FACILITY: Palo Verde Nuclear Generating Station, Units 4 and 5

SUBJECT: SUMMARY OF MEETING HELD ON OCTOBER 19, 1978 REGARDING
THE SAFETY REVIEW OF PALO VERDE, UNITS 4 AND 5

REQUEST FOR ADDITIONAL INFORMATION

Figure 8.2-5

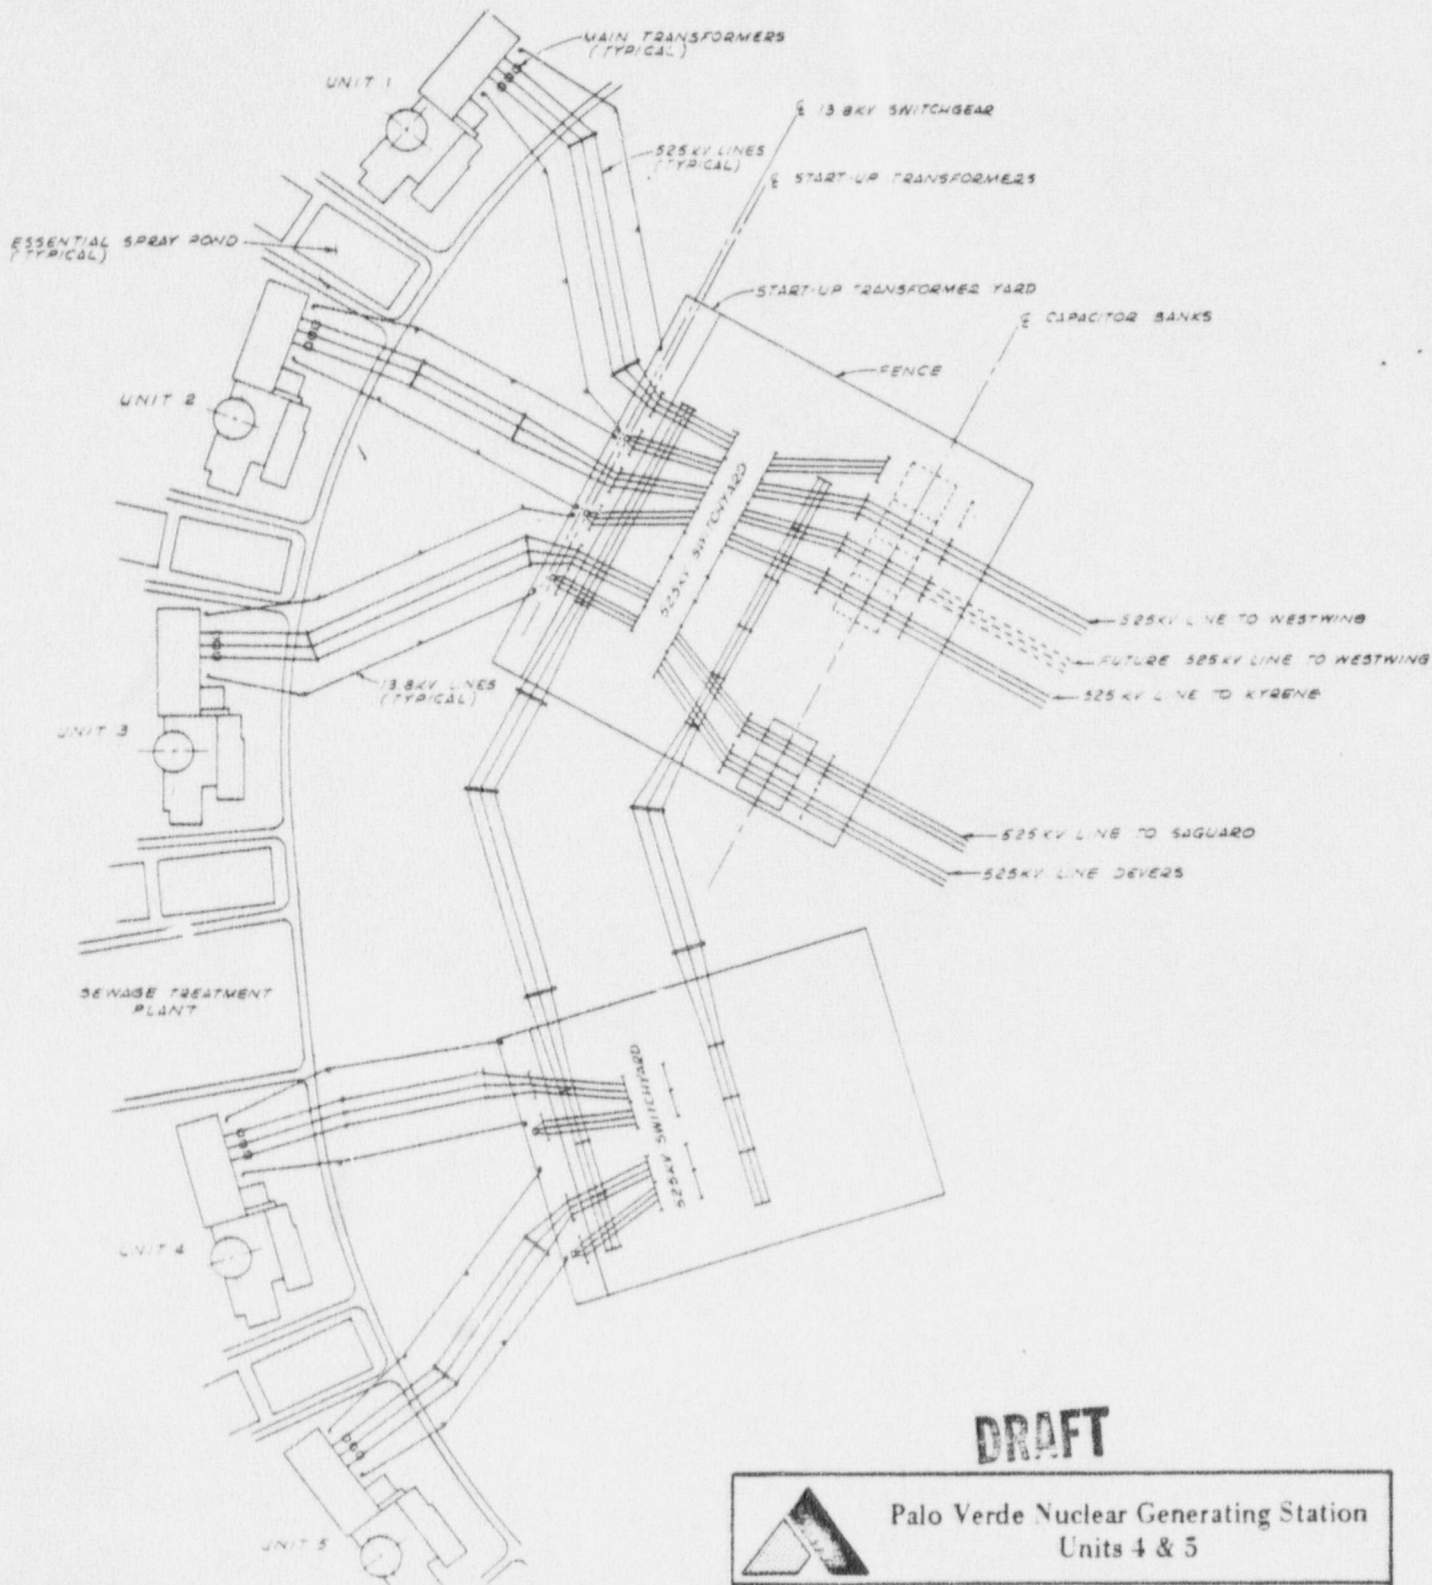
Provide physical layout drawings of the circuits that connect the Units 1, 2 & 3 switchyard to the Units 4 and 5 switchyard and the onsite distribution system to the preferred power supply. In addition, provide assurance that physical separation of overhead bus extension lines that connect the Units 4 and 5 switchyard to the Units 1, 2 and 3 switchyard is sufficient so as to minimize the likelihood of simultaneous failure of both lines.

The overhead bus extension lines that connect the Units 4 and 5 switchyard to the Units 1, 2 and 3 switchyard will maintain the same 570 foot centerline to centerline spacing as the switchyard busses to which they connect. They will pull straight off the busses and will not exceed the phase spacing and tower height of the plant to switchyard 500kv line segments, which are 46 feet and 127 feet, respectively.

If one line were to physically fail, with a tower falling directly toward the other line, there would still be 351 feet of clearance (minimum) between the top of the tower and the nearest phase of

the second line.

Revised PVNGS-425 PSAR Figure 8.2-5, attached, depicts the layout of the offsite to onsite power system connections.
